Appendix 6: Geotechnical Investigation and RFI response letter

18 February 2021

CH00417

PC200072: TRICES ROAD REZONING GROUP PRIVATE PLAN CHANGE- RESPONSE TO REQUEST FOR FURTHER INFORMATION

Drawing G00417-02

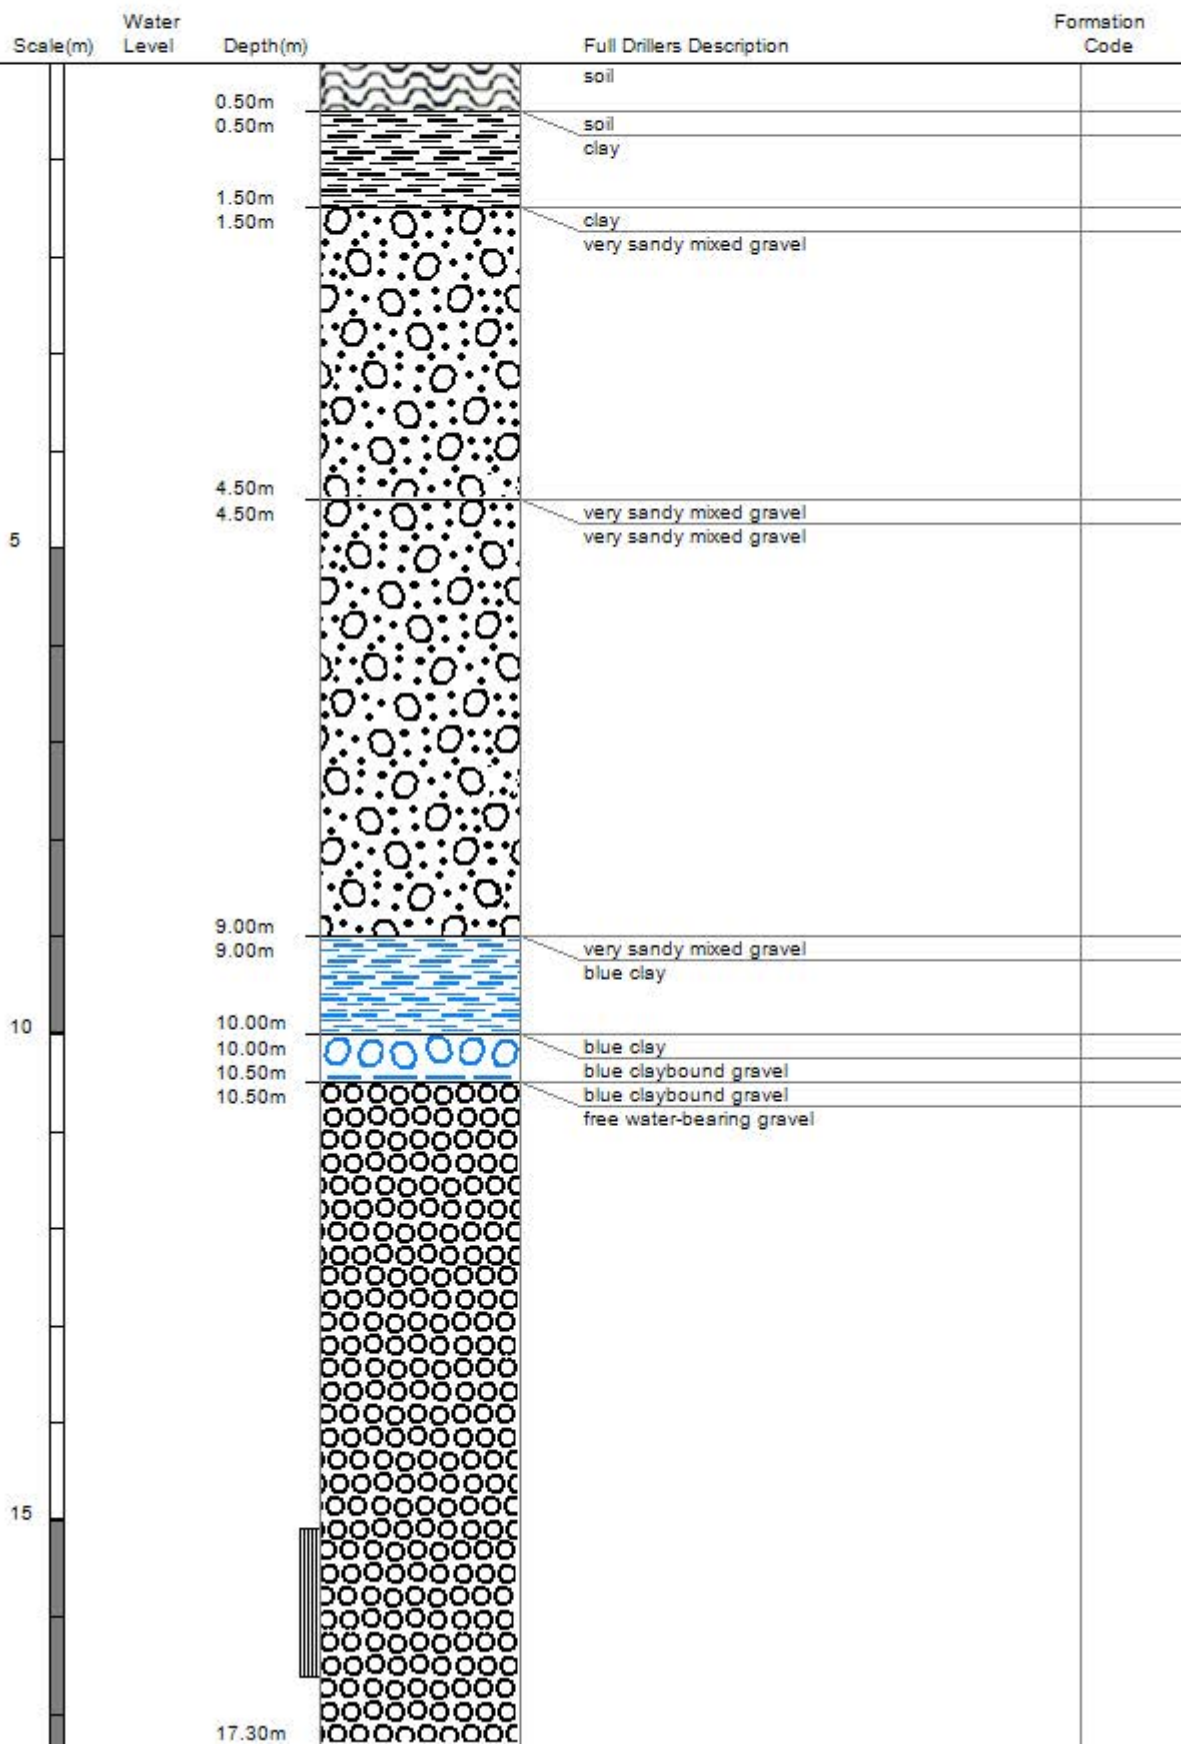
“Please supply the test data from the NZGD (location and logs) used to help identify the soil profile (8.3).”

“Please supply the Ecan well logs and locations used to model the gravels as extending to 18m depth (8.3).”

The test pits are located at a site abutting the western site boundary. The approximate inferred location and extent of these test pits are shown on the appended Fraser Thomas Ltd drawing G00417-02.

The approximate inferred location and extent of the relevant water bores are shown on the appended Fraser Thomas Ltd drawing G00417-02.
